Suggested Topics for Further Discussion  
Regarding Industry's Proposed Approach to  
Risk Informing ASME SEC. XI App. G

# Approaches Proposed by Industry at 21 August 2008 Meeting

# NRC Suggestions for Discussion

# NRC Understanding of Industry Proposed “Modified App. G Approach”

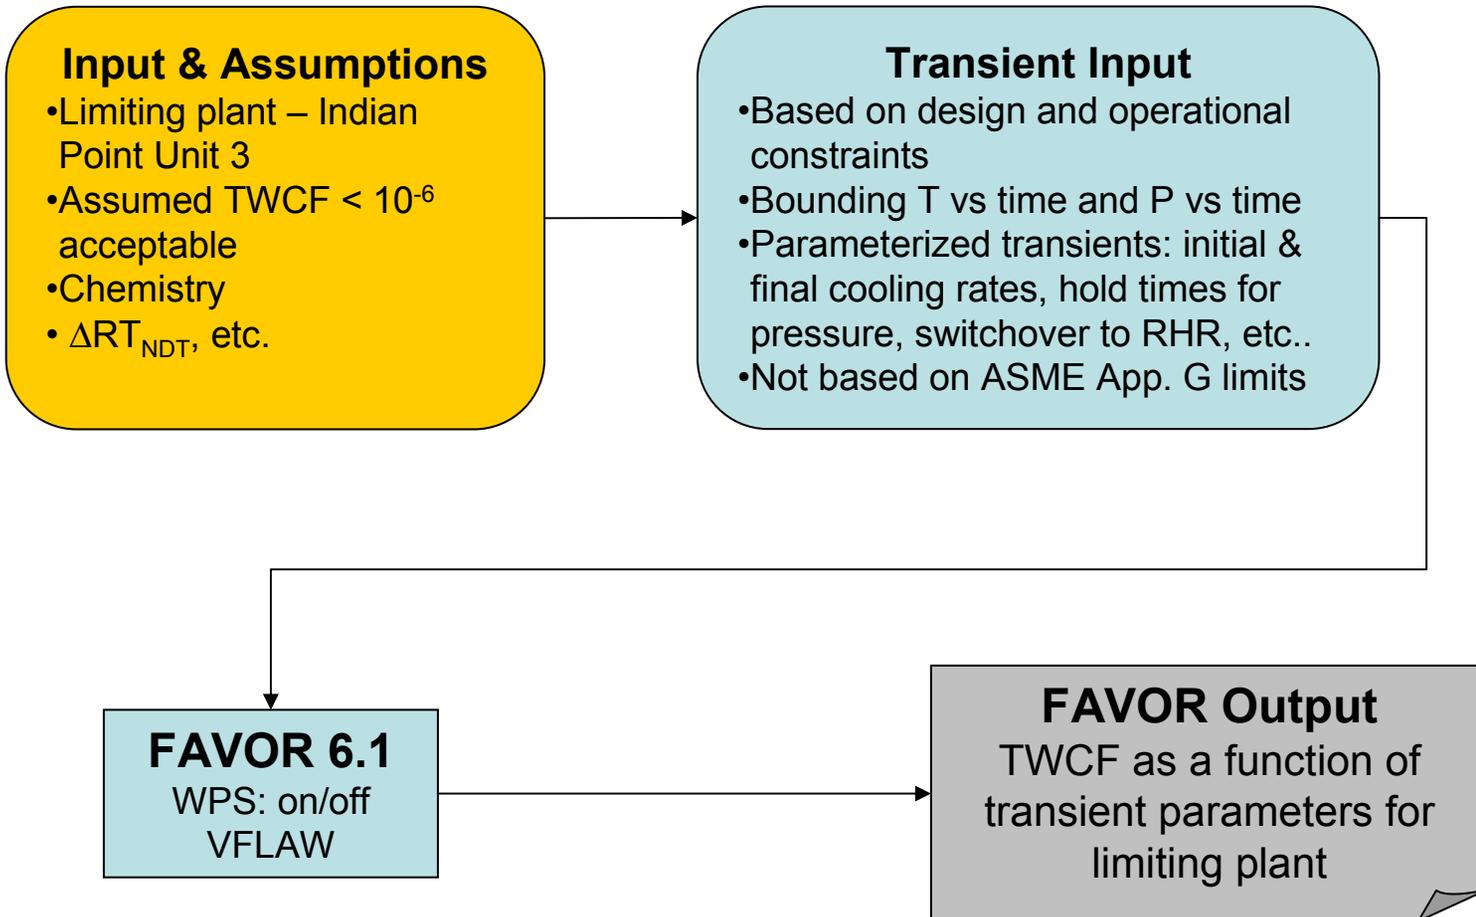
- As summarized in the earlier slides, at the meeting on 21 August we understood two different approaches to risk-informing Appendix G to have been presented. Perhaps this understanding was mistaken. We suggest you discuss how what we have identified as two different approaches (this may or may not be true) both contribute in a consistent and integrated manner toward the risk-informed revision of Appendix G. Also, we suggest you comment on / correct any inaccuracies that you see in our explanation of your two different approaches.
